Work Order ID: 95429
Parent Item: D350-689-013
Parent Item Name: Floor Provisions

DART SERVICE INSTRUCTION

TO AMEND INSTALLATION INSTRUCTIONS IIN-D350-689 REV. B AND INSTRUCTIONS FOR CONTINUED AIRWORTHINESS ICA-D350-689 REV. 1

FIGURE 1: UPDATES TO CROSS SECTIONS F-F AND M-M
 With reference to Figures 5 and 7 of IIN-D350-689
 (Figures 25-5 and 25-7 of ICA-D350-689)

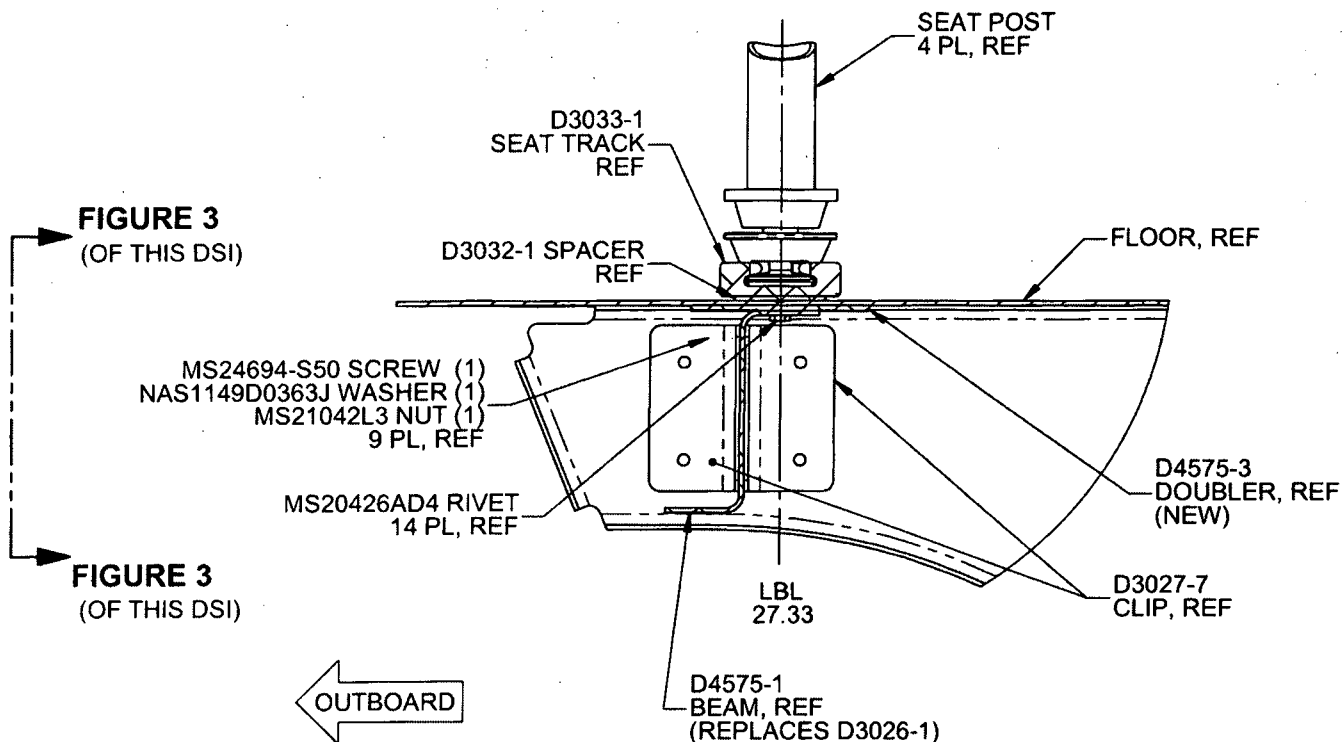
If there is an existing stringer at LBL 27.33, it will need to be removed from that location. Locate D4575-1 Beam, D4575-3 Doubler, and D3032-1 Spacer as shown in Figure 1 of this Service Instruction. Transfer drill existing holes from the aircraft floor to the D4575-1 Beam, D4575-3 Doubler, and D3032-1 Spacer. Ensure 1.0" to 1.5" rivet pitch and add additional holes if required. If there is no existing stringer, locate D4575-1 Beam, D4575-3 Doubler, and D3032-1 Spacer as shown in Figure 1 of this Service Instruction and drill Ø0.128" holes on a 1.0" to 1.5" pitch.

Counter sink holes in the D3032-1 Spacer for MS20426AD4 rivets. Install D4575-1 Beam, D4575-3 Doubler, and D3032-1 Spacer to floor using MS20426AD4 rivets.

CROSS SECTION VIEW F-F/M-M: From Figures 5 and 7 (IIN-D350-689)
CROSS SECTION VIEW F-F/M-M: From Figures 25-5 and 25-7 (ICA-D350-689)

FIGURE 2: UPDATES TO FIGURE 21 (IIN-D350-689) AND 25-21 (ICA-D350-689)

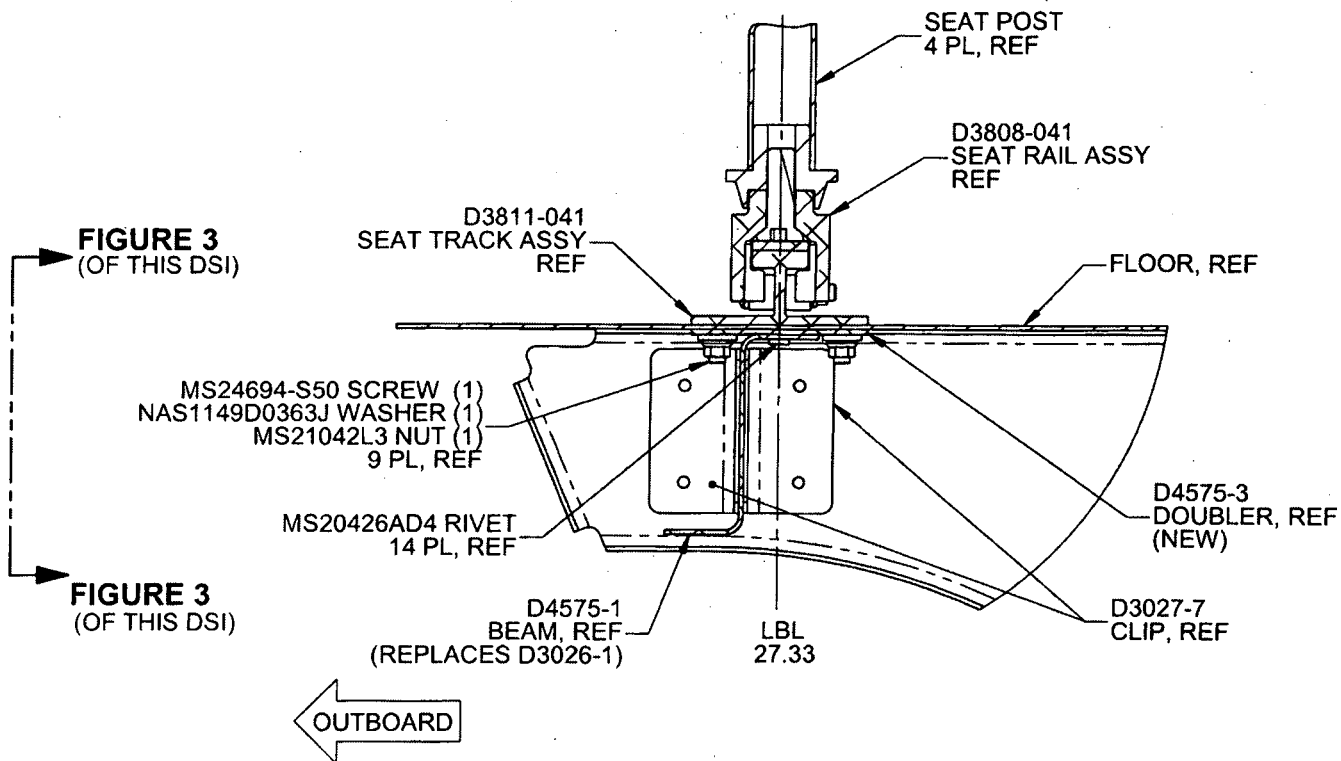
If there is an existing stringer at LBL 27.33, it will need to be removed from that location. Locate D4575-1 Beam and D4575-3 Doubler as shown in Figure 2 of this Service Instruction. Transfer drill existing holes from the aircraft floor to the D4575-1 Beam and D4575-3 Doubler. Ensure 1.0" to 1.5" rivet pitch and add additional holes if required. If there is no existing stringer, locate D4575-1 Beam and D4575-3 Doubler as shown in Figure 1 of this Service Instruction and drill Ø0.128" holes on a 1.0" to 1.5" pitch.

Attach D4575-1 Beam and D4575-3 Doubler to floor using qty (14) MS20426AD4 rivets.

FIGURE 3: RELIEFS ON D4575-1/-3
(ONLY D4575-1/-3 SHOWN FOR CLARITY)
VIEW LOOKING INBOARD

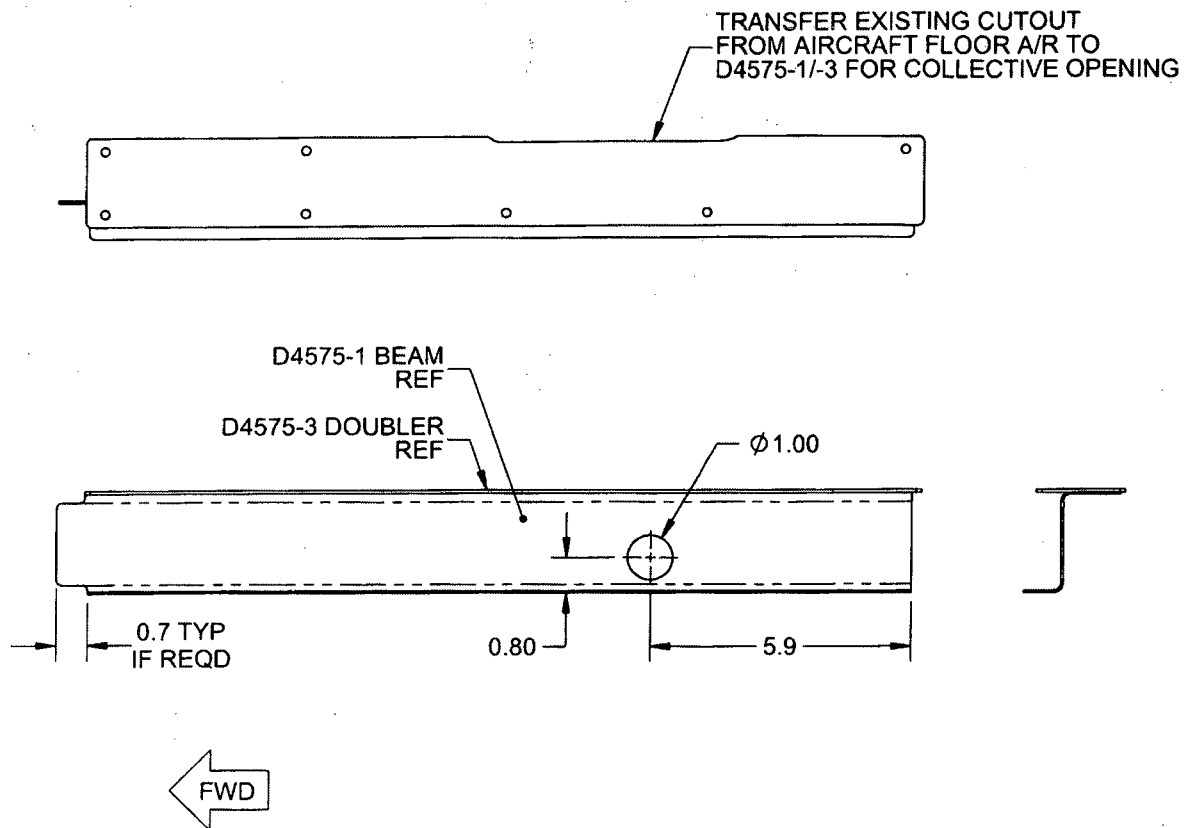
Note: Drill a Ø1.00" (Ø25.4 mm) hole in the D4575-1 Beam to clear extension tube of collective and cutout as required for clearance of collective opening and fwd bulkhead as shown in Figure 3 of this Service Instruction.

Note: Drill a Ø1.00" (Ø25.4 mm) hole in the D4575-1 Beam to clear extension tube of collective and cutout as required for clearance of collective opening and fwd bulkhead as shown in Figure 3 of this Service Instruction.
